BOARD OF SUPERVISORS

ITEM #11

File Number: PLN2017-00320

Location: 240 Capistrano Road, Princeton

CONCEPTUAL PLANNING COMMSSION CONDITIONED SITE PLAN
COUNTY OF
CAN MATEO

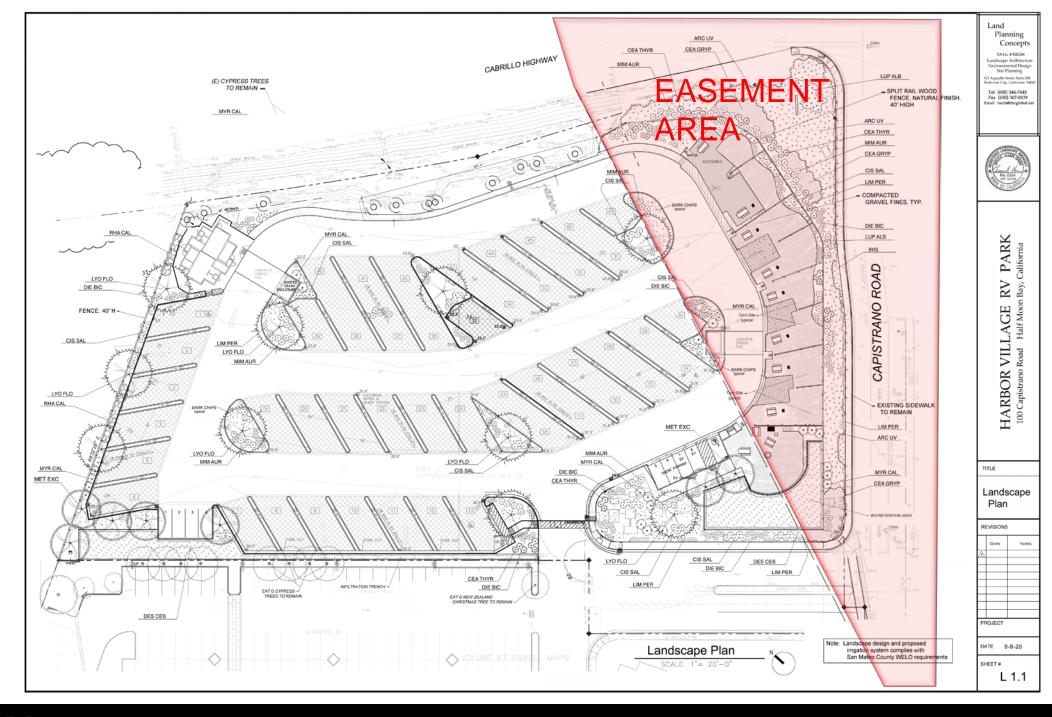
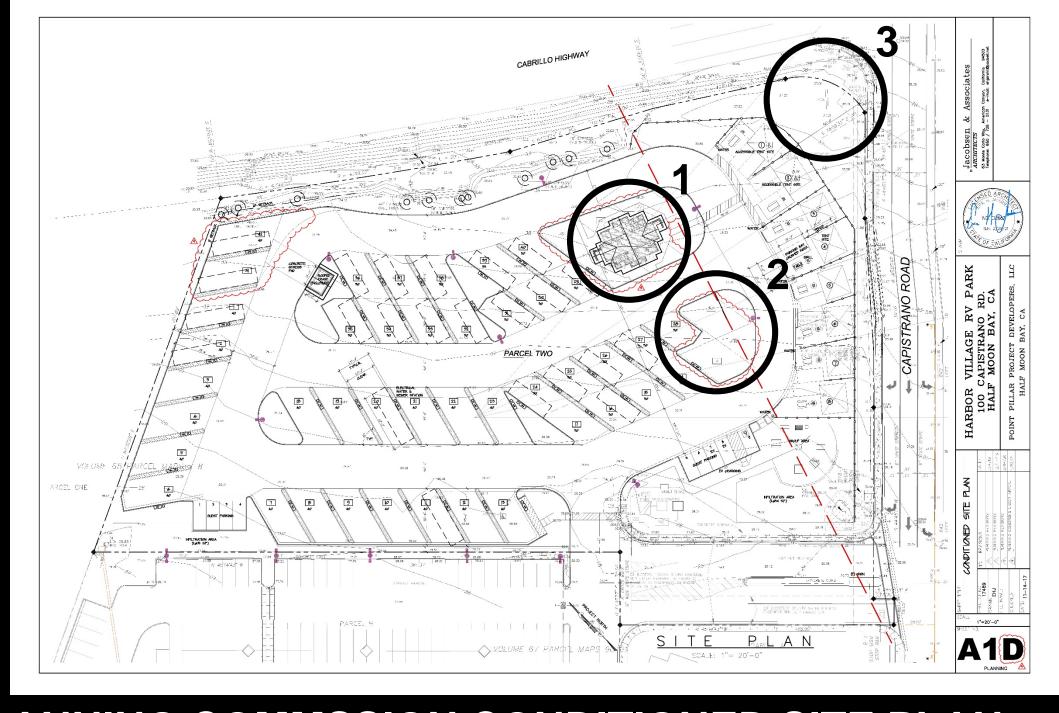
1 - RELOCATION OF BUILDING

2 - ADDITIONAL LANDSCAPE SCREENING

3 - SIZE REDUCTION OF SIGN STRUCTURE

APPEAL POINT: LAUNDRY/SHOWER BUILDING RELOCATION

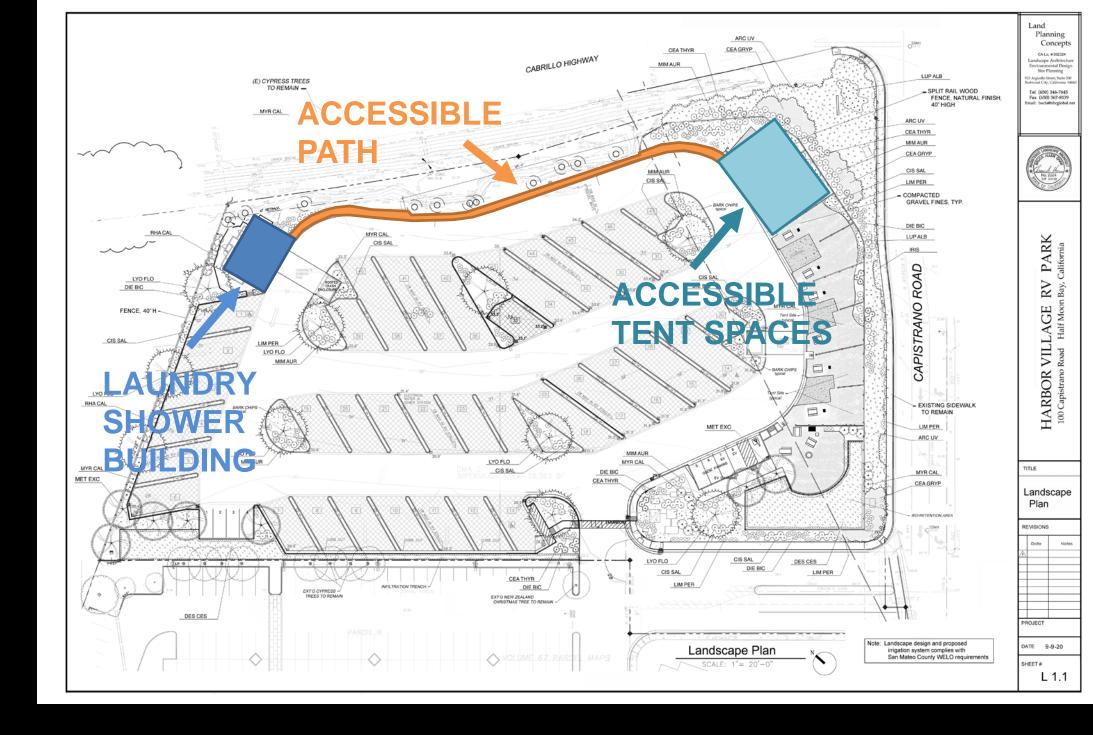
The new building location, as required by Condition 21(a), would not be aesthetically pleasing, results in loss of RV spaces, creates circulation issues, and does not provide additional landscape screening.

- Building location is outside of the proposed Clear View Easement
- Opportunity for landscape screening increased
- Shortens necessary accessible paths
- Prevents root loss and damage for mature Cypress trees along Highway 1

CONCEPTUAL PLANNING COMMISSION CONDITIONED SITE PLAN COUNTY OF

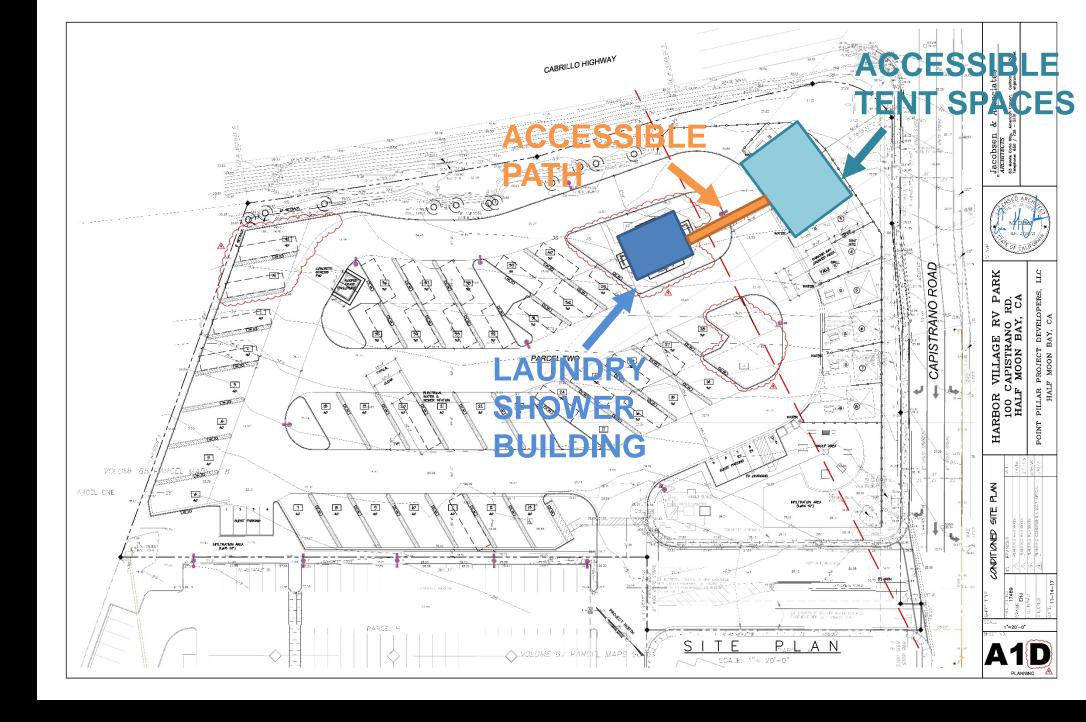
The reduction of the size of the existing sign structure at the corner of Capistrano Road and Highway 1 to a maximum of 6 ft high and 9 ft wide, as required by Condition 21(c), is overreaching in that the sign structure is not part of the scope of the project.

- Existing and proposed elements evaluated holistically
- Size reduction minimizes visual obstructions within the proposed
 Clear View Easement area, restoring ocean views from Highway 1
- Consistent signage style with existing monument sign at Capistrano Road and Pillar Point Harbor Boulevard intersection

APPEAL POINT: ADDITIONAL LANDSCAPE SCREENING UNNECESSARY

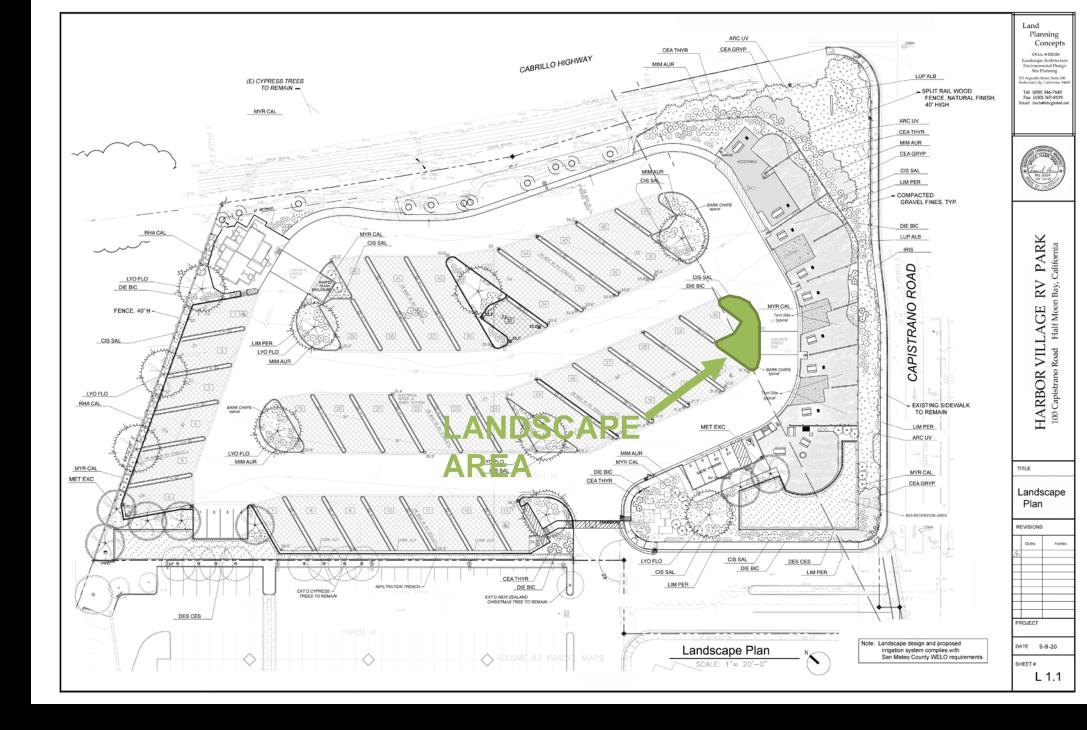
The addition of robust landscape screening at the end of the lower interior row through the elimination of 2 RV spaces, as required by Condition 21(b), is unnecessary as screening from locations along Capistrano Road is provided and the loss of spaces reduces the profitability of the project.

- Elimination of spaces will provide opportunity for enhanced landscape screening as larger, taller growing plants can be located in areas outside of the Clear View Easement area
- The addition of tree(s) in the island will provide continuity in the landscape plan
